**Our ref:** R/5224\_18\_Fishguard Port/JFO

**FORMAL REQUEST FOR ADVICE ON SEDIMENT SAMPLE ANALYSIS ADVICE  
RESULTS FOR STENA LINE LINKSPAN REPLACEMENT IN FISHGUARD  
REF: CML2533**

1. With reference to your request dated 23 June 2025, for advice on the sediment sample analysis results relating to the above marine licence application (CML2533) for Stena Line Linkspan Replacement in Fishguard, please find the advice below.

Figure 1. Dredge areas and sample locations provided by RPS (Figure 2-9 in Environmental Statement)

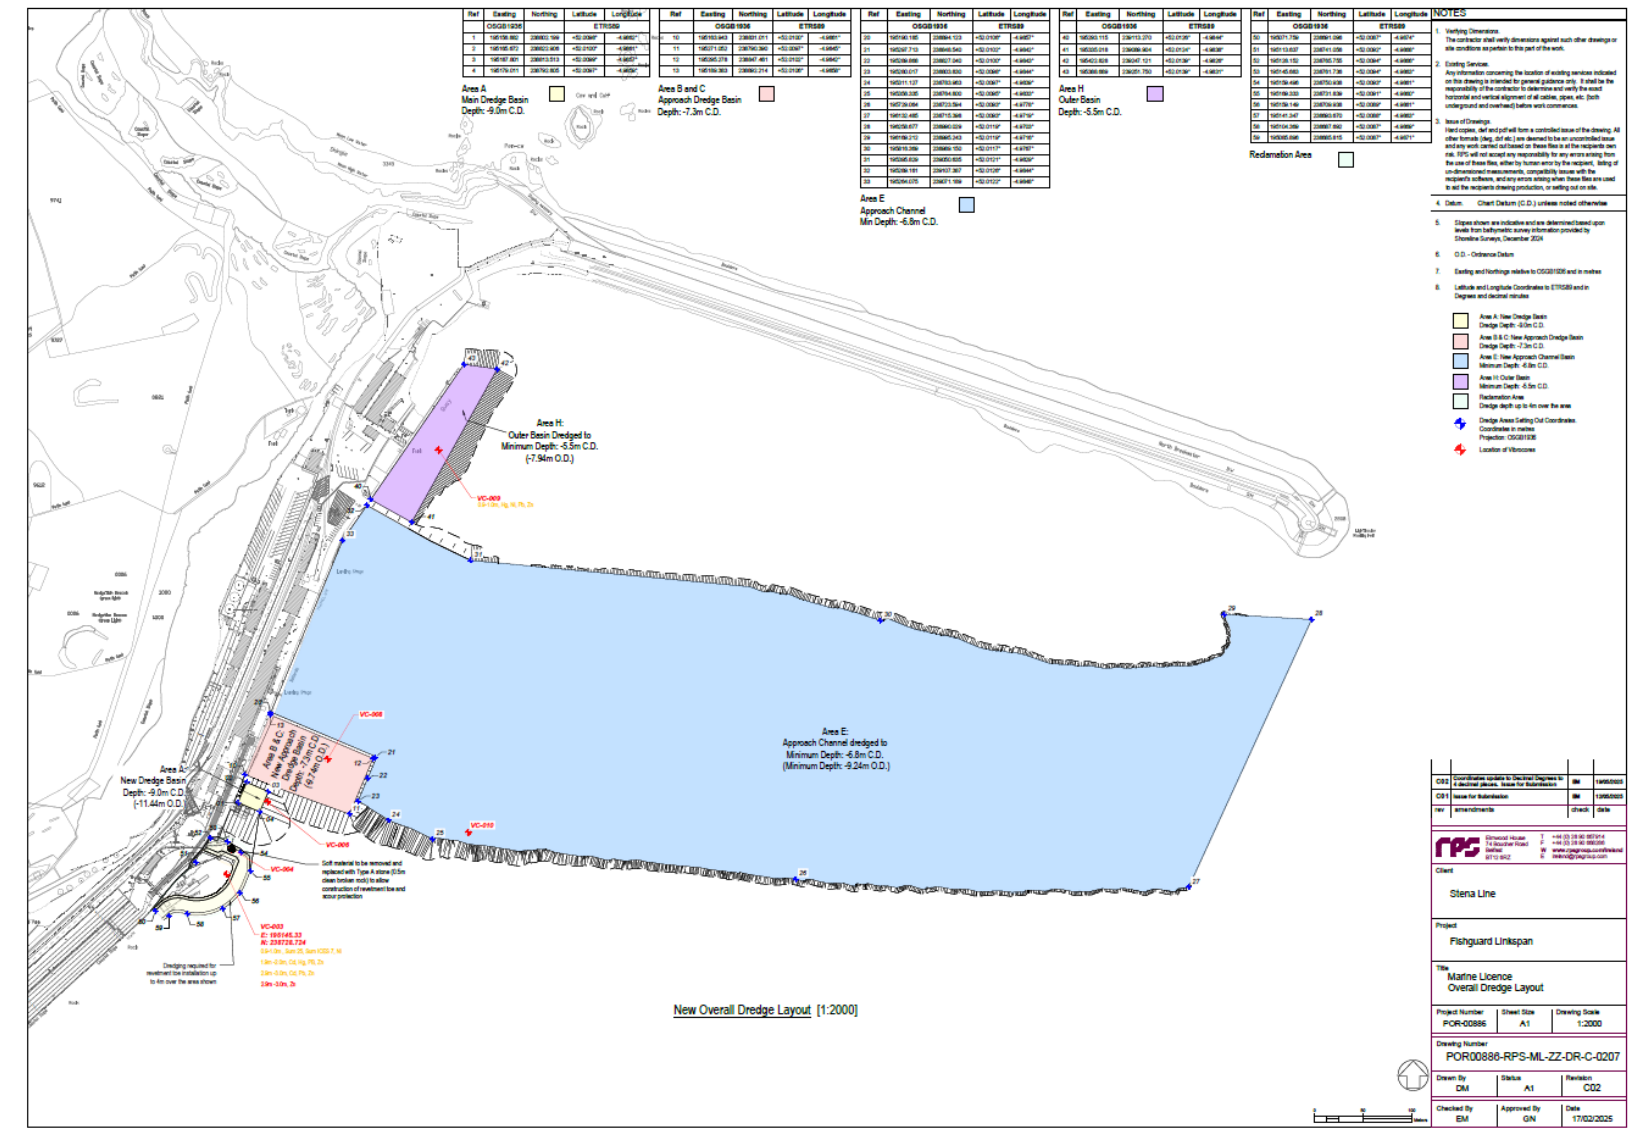
4. The proposed areas to be dredged have been named 'A', 'B', 'C', 'E', and 'H', and a 'Reclamation Area' is also required to be dredged. These areas are shown in Figure 1 (taken from Figure 2-9 of the ES). The approach channel (Area E) and new approach dredge basin (Area B and C) is proposed to be dredged to depths ranging between -7.3m CD and -6.8m CD. The outer basin (Area H) will be dredge to -5.5m CD. A new dredge basin (Area A) will be dredged to -9.0m CD. The area of land reclamation requires around 4 m depth of material to be removed. In total, allowing for contingency, 78,000m<sup>3</sup> of capital dredging is expected.

11. Sample VC-003 2.90 – 3.00m ES3 in the Reclamation Area (sample depth 2.9 m to 3 m) had elevated concentrations of zinc. The measured concentration is 907 mg/kg which is above Cefas Action Level 2 (AL2) (800 mg/kg). Therefore, material from this sample location and depth would not be considered suitable for disposal at sea. The Applicant states in Section 11.10.2 of Chapter 11 of the ES: *“key mitigation for the dredging activities is to avoid the disturbance of the layer of contamination found at 3 metre depth (-3.43m to -3.53m C.D). The design has been developed to ensure that the contaminated sediments at 3 metre depth will not be disturbed when the land reclamation activities are being undertaken. The section in Figure 11.3 demonstrates that the design and the approximate extent of material to be removed will avoid this contamination at depth.”* However, according to the ‘Marine Licence Overall Dredge Layout’ drawing (Figure 1), the vibrocore sample location is positioned outwith the area of dredging required for the revetment toe installation (located approximately 20 m north and west). There is therefore some uncertainty on whether VC-003 is representative of the area to be dredged, and the extent of contamination. Approximately 7,400 m<sup>3</sup> of material is required to be dredged from this location. Furthermore, Sample VC-003 1.90 – 2.00m (1 m above the contaminated layer) has concentrations of zinc and lead above Cefas AL1, which suggests contaminated material may also be present above 3 m depth. Based on this, additional sampling at regular depth intervals is recommended within the area to be dredged for the revetment toe installation to determine extent and depth of contamination, and suitability of the material for disposal at sea. Alternatively, on a precautionary basis, the Applicant could consider restricting dredge material below 2 m depth within the Reclamation Area from disposal at sea.

17. In summary, the results indicate that the majority of material proposed to be dredged as part of the Stena Line Linkspan Replacement in Fishguard project is acceptable for disposal at sea. Material below 2 m depth within the Reclamation Area, and material up to 1.9 m depth within Area H presents a potentially unacceptable risk due to elevated concentrations of zinc and PAHs. It is therefore recommended that:

- Additional sampling is conducted within the dredge area required for the revetment toe installation (Reclamation Area) and around VC-009 (Area H). This is required to better understand the extent and depth of contamination and determine the suitability of material within the Reclamation Area and Area H for disposal at sea; or

- Material dredged below 2 m depth within the Reclamation Area, and material up to 1.9 m depth within Area H is excluded from disposal at sea if a licence is granted.

Figure 2. Sum of low molecular weight (LMW) polycyclic aromatic hydrocarbons (PAHs) compared to effects-range low (ERL) and effects-range medium (ERM)

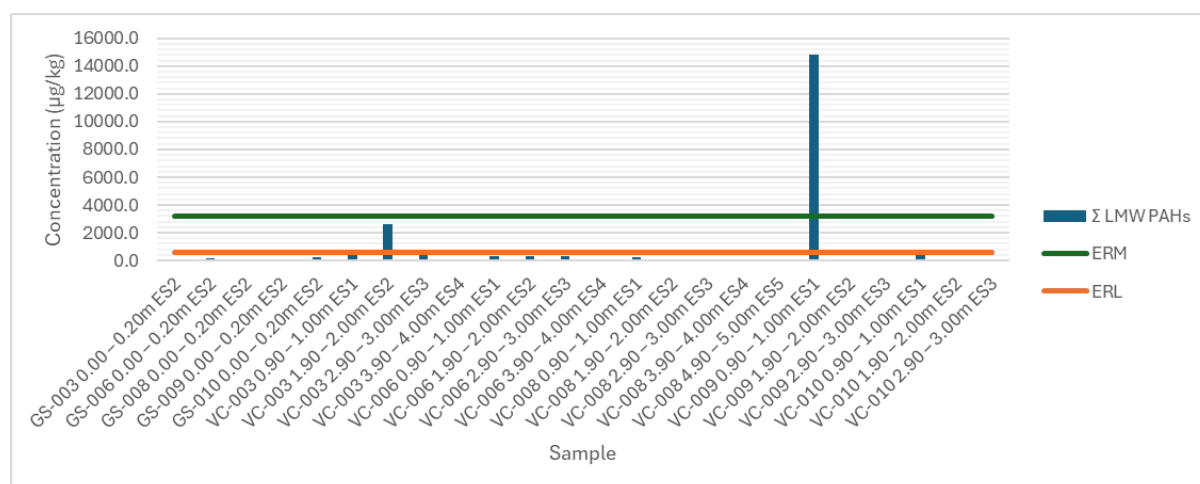
14. For both LMW and HMW PAHs, VC-009 0.90 – 1.00m ES1 (Area H) far exceeded the ERM (see Figure 2 and Figure 3). Therefore, material represented by this sample from Area H would be considered higher risk to the environment and is potentially not suitable for disposal at sea. We recommend that additional sampling is undertaken within Area H to ascertain whether the concentrations observed at VC-009 0.90 – 1.00m ES1 are anomalous (i.e., a “hotspot” of localised contamination), or whether they are representative of the area as a whole. If further sampling data shows a localised area of contamination, this may support a case for a smaller dredge area or depth to be restricted from disposal at sea. Alternatively, material down to 1.9 m depth in Area H (which is the next sample depth in Area H) should be restricted from disposal at sea.
